ENVIRONMENTAL ASSESSMENT FOR A
SHORE PROTECTION BERM AT
91-873 POHAKUPUNA ROAD, EWA BEACH
TMK 9-1-25:54

COMMENTS ON DRAFT ENVIRONMENTAL ASSESSMENT AND RESPONSES

Project Name : Suga Shore Protection Structure
File No. : 92/SV-8 (JT)
Tax Map Key : 9-1-25: 54

FIGURE 7. BERM PLAN VIEW AND ELEVATION CONTOURS

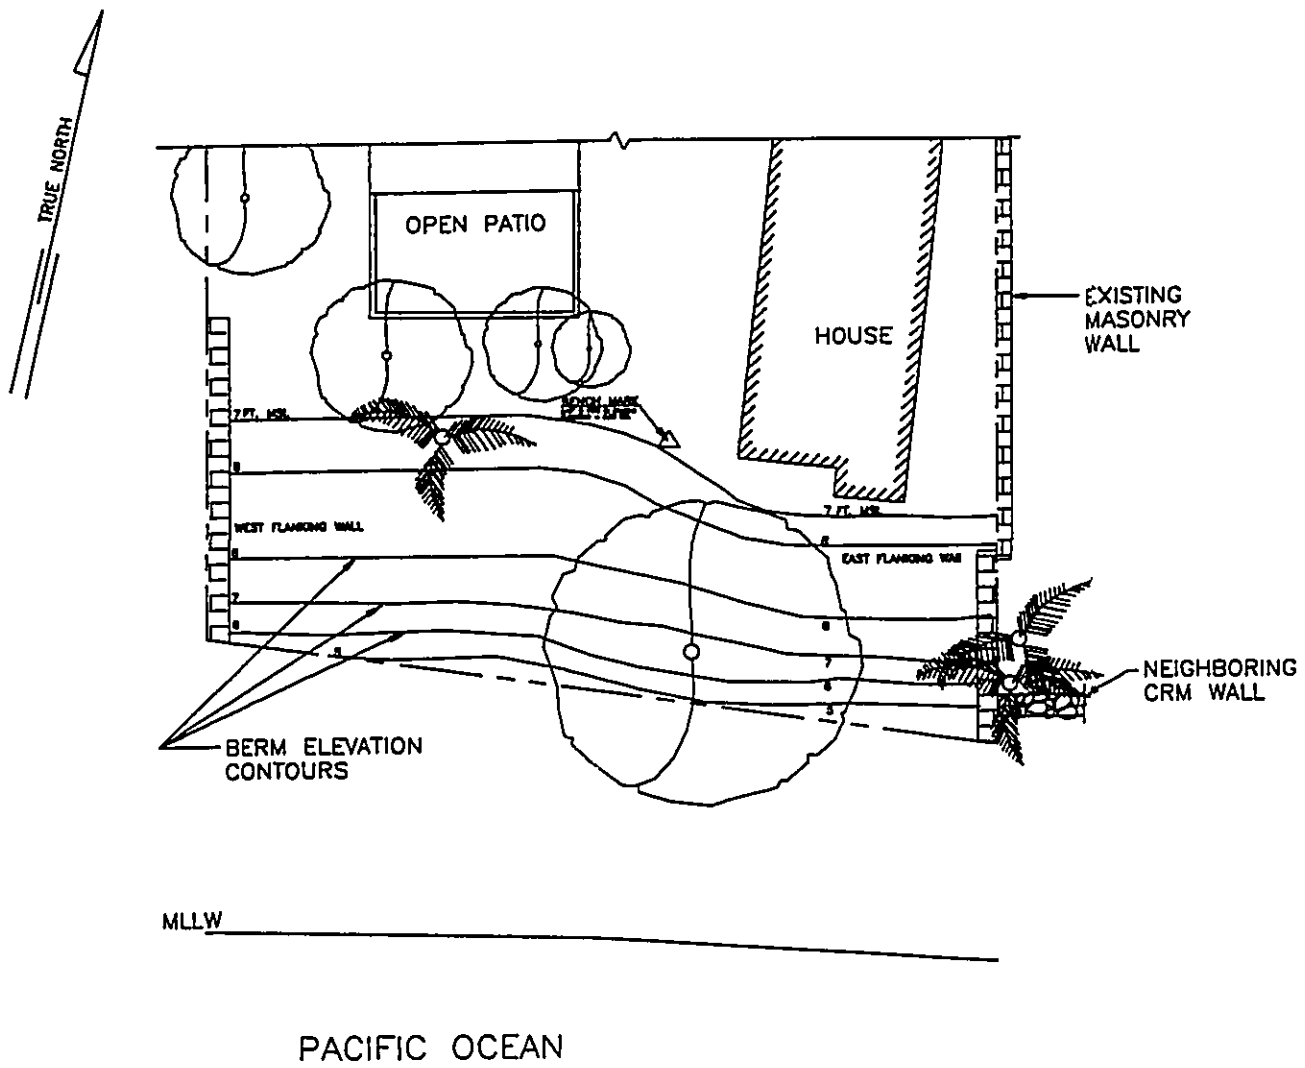
1. The new coral gravel berm and proposed flanking
walls are to be constructed entirely on the applicant's
property and not encroach on the State's Conservation
land.
2. The applicant take the necessary steps to remove
any coral that might spill over from the berm onto
State land should such occur.

1. The new coral gravel berm and flanking walls will be constructed entirely on the applicants property and will not encroach on the State's Conservation Land.
2. Any coral spilling onto State land will be removed.
